Attachment A

1. Replace Technical Specification page 6.2-3 with the enclosed page.

Attachment B

FIGURE 6.2-1

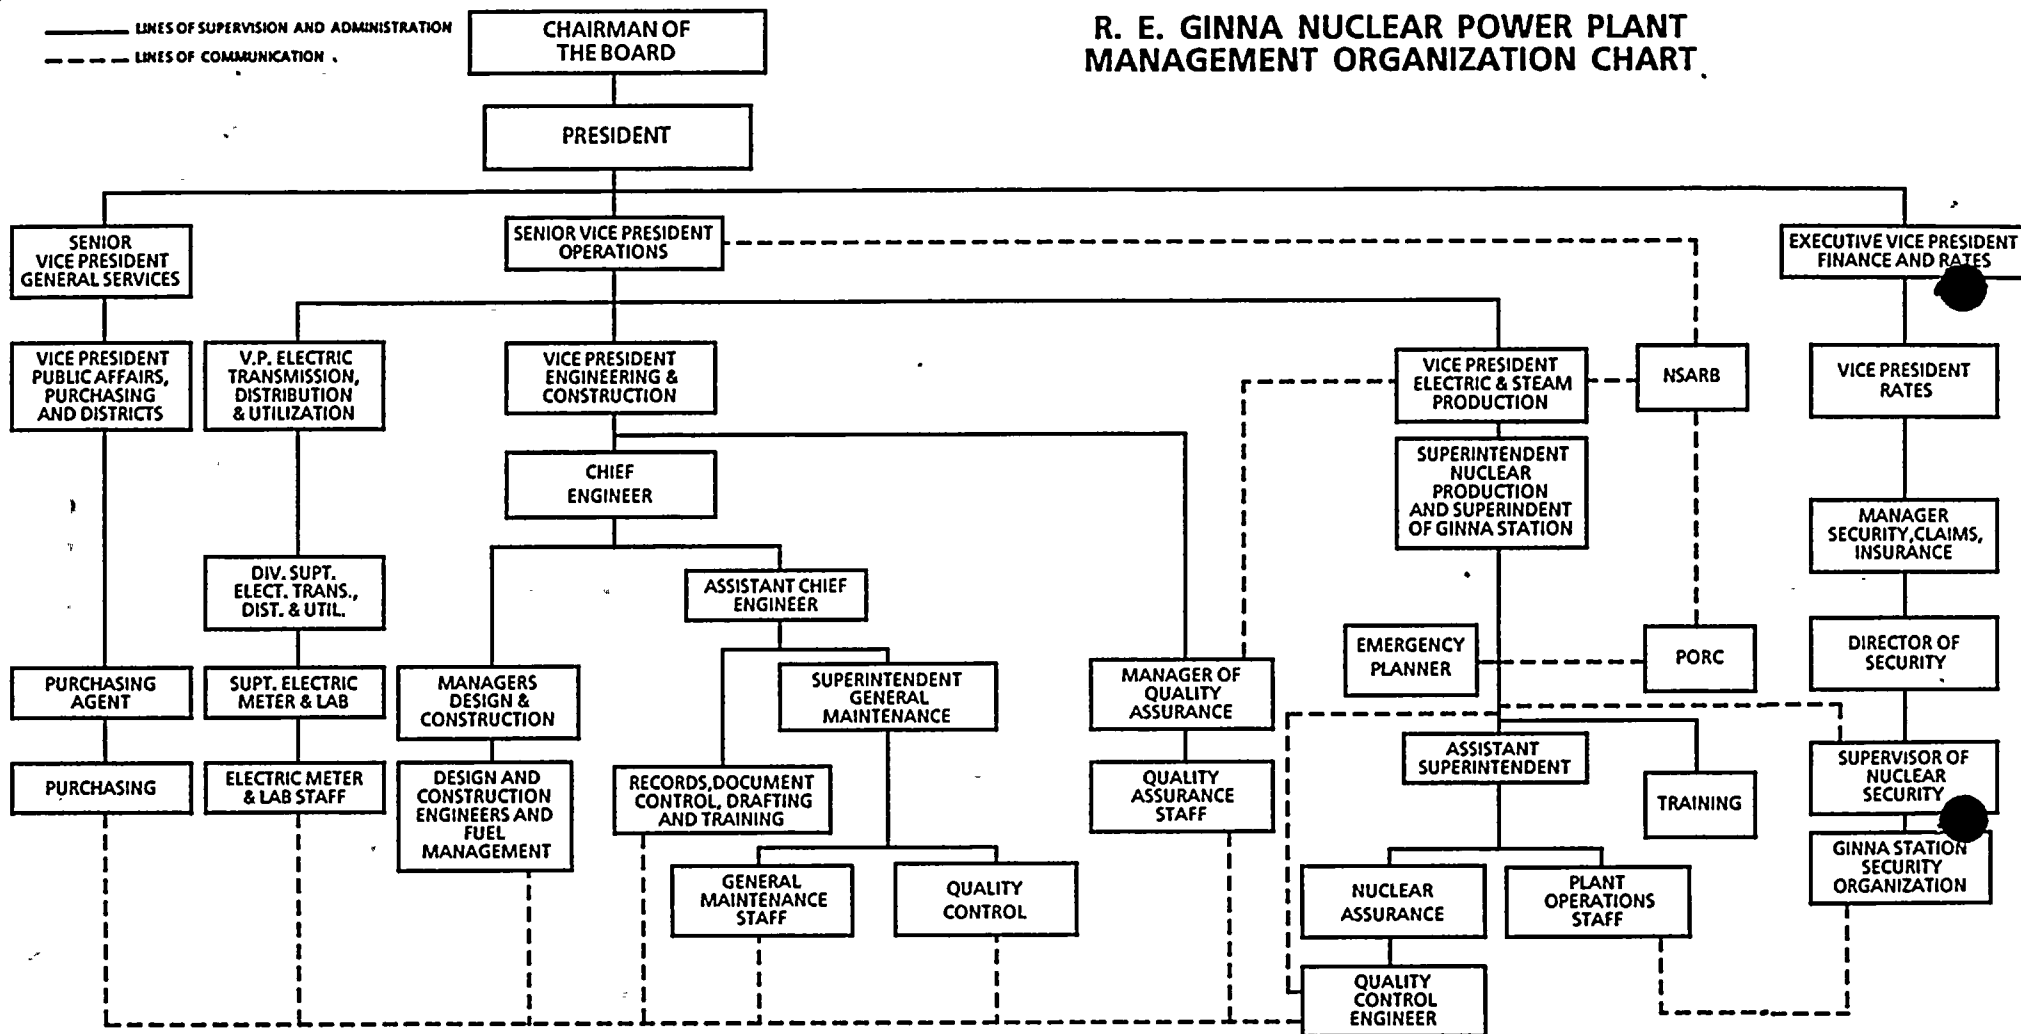
The proposed Technical Specification change reflects changes in the RG&E management organization. A realignment of responsibilities in the Engineering organization has resulted in a change in title whereby the Engineering Department now reports to the Vice President, Engineering and Construction, and a position of Chief Engineer has been created. The position of Assistant Chief Engineer, Engineering and Construction, has been deleted at this time although it is anticipated that there may be further minor changes in the Engineering organization at this level and below in the future. In order to maintain independence of the Quality Assurance organization from the design, construction and other engineering functions, Quality Assurance now reports to the Vice President, Engineering and Construction, instead of the Assistant Chief Engineer.
